Burlington Development Review Board

Development Review Board

Tuesday, August 20, 2024, 5:00 PM

ZP-24-262; 228 North Winooski Avenue (NMU, Ward 2) Champlain Housing Trust / Eli Maroscher

SCHEMATIC SITE PLAN

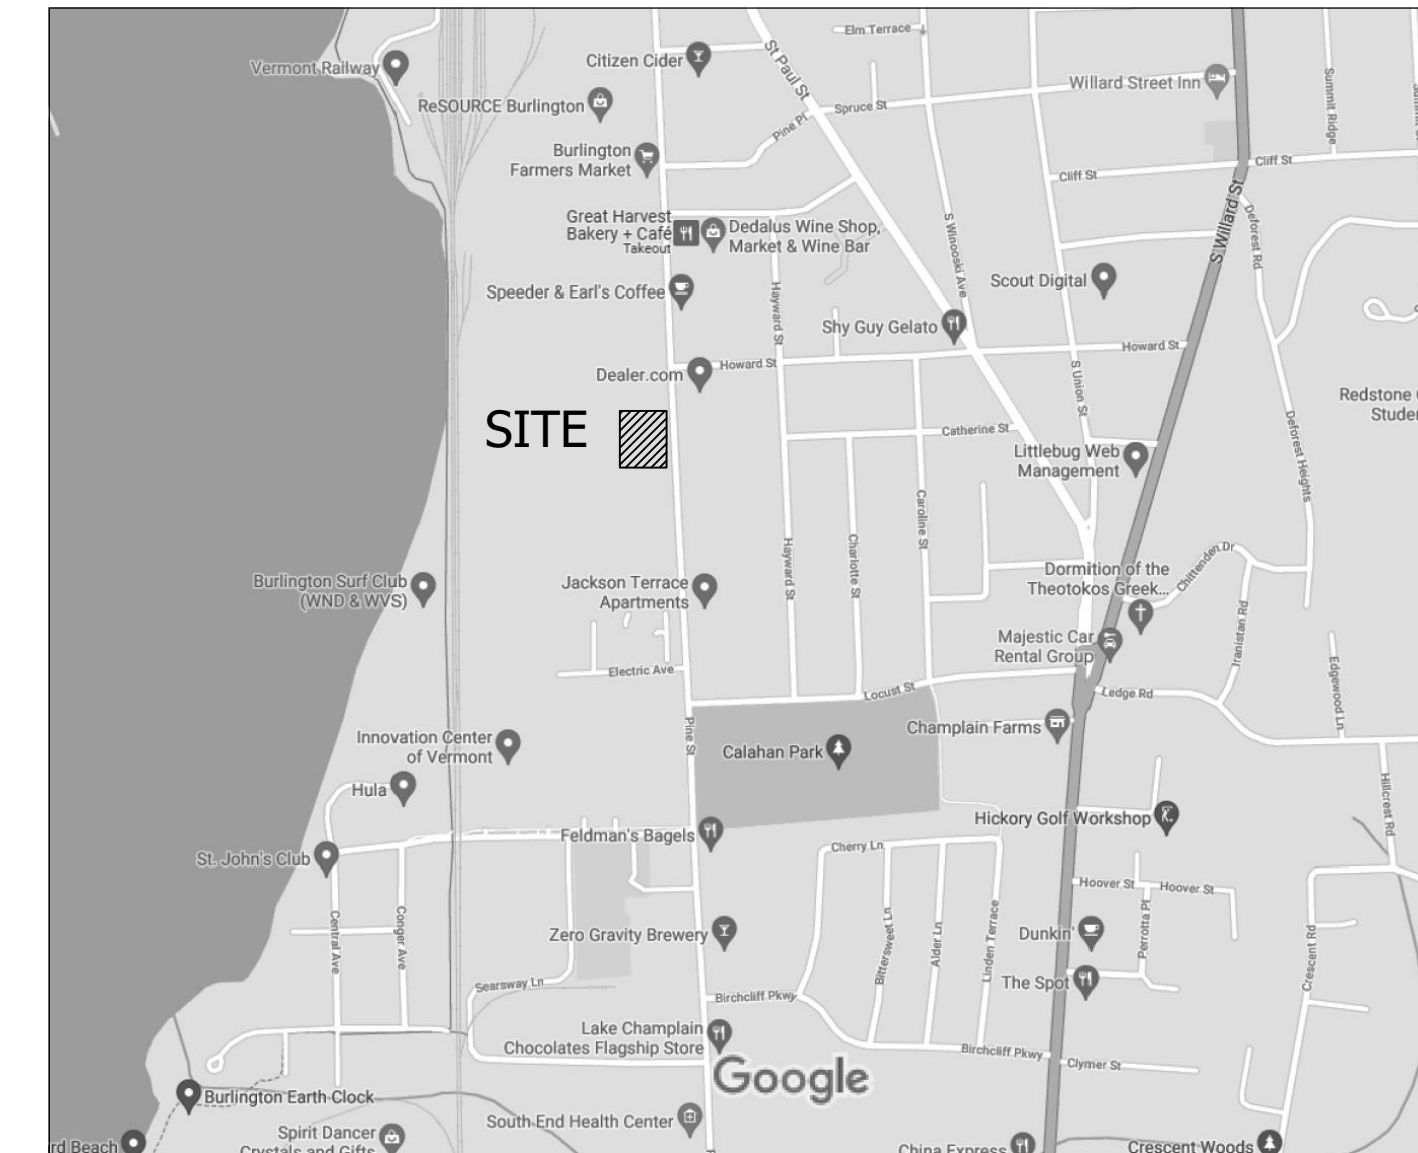
The development proposes direct access off Pine Street with two curb cuts to allow for an easy, one-way circulation pattern. See site plan. **(Affirmative finding)**

The site plan shows two planter boxes that will act as a barrier to the area behind the flanking trailers. Also included is ornamental grass in the Pine Street right-of-way greenspace. A retaining wall will be installed along the rear and south side property lines, and along a small portion of the north side property line. **(Affirmative finding)**

Electric and water utilities will be provided underground. No other utilities are proposed. The site plan identifies trash/recycling areas. Standard waste/recycling bins will locate in front of the side-flanking containers where customers will pass on their way off the site. These bins will need to be visually screened from the Pine Street right-of-way. Larger trash/recycling bins will

4. **Prior to the release of the zoning permit**, the plans shall be revised to include the following:
 - screening of the trash/recycling bins located in front of the container kitchens; and

15 NORTH ELEVATION
Scale: 3/16" = 1'-0"

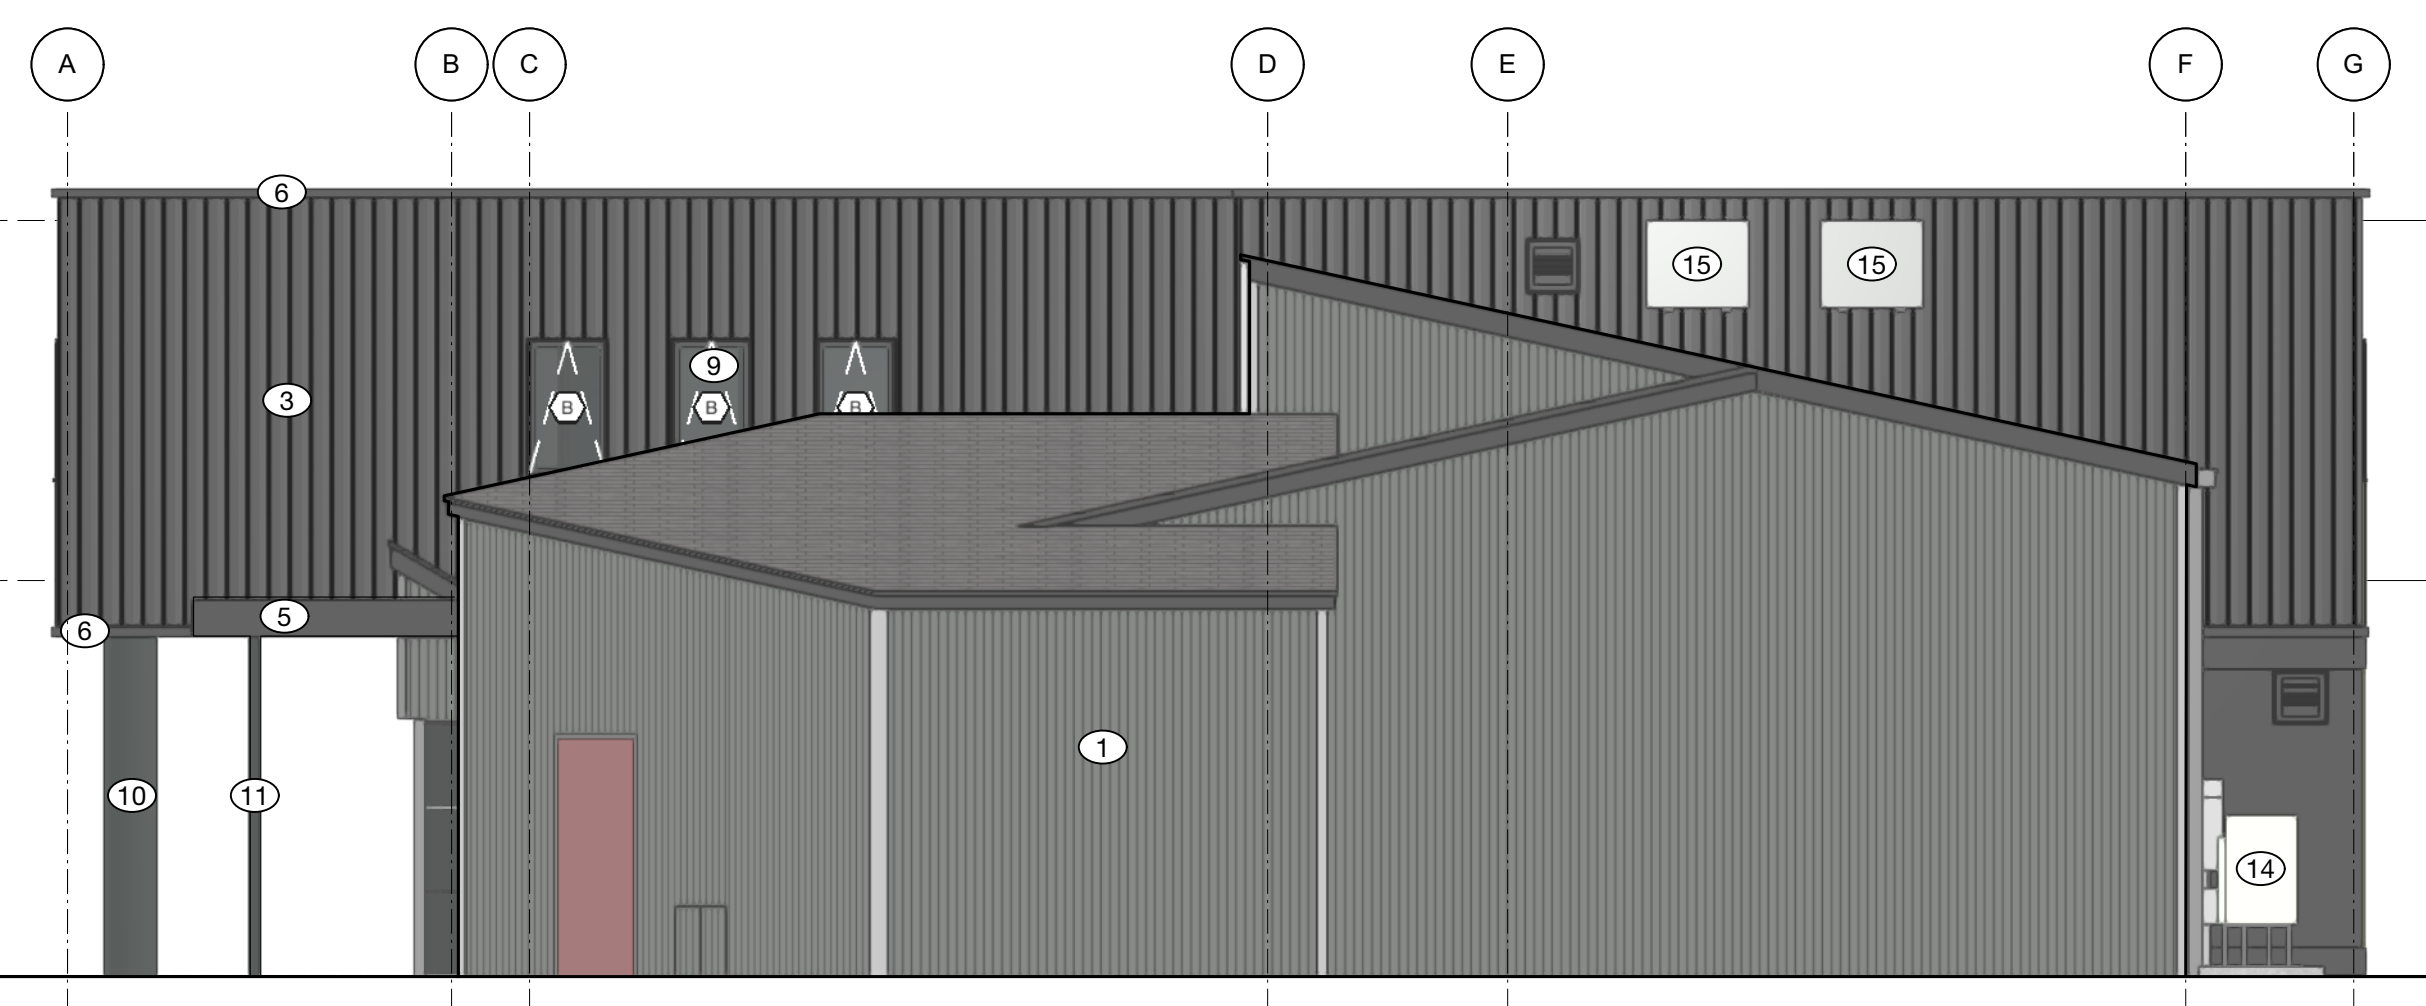
The north elevation features windows at the 2nd floor only. Side yard setbacks for NMU are 0’; 2’ are proposed. Additions to existing buildings placed on a side or rear property line, or within 10’ of another building where no setback is required are subject to construction material and
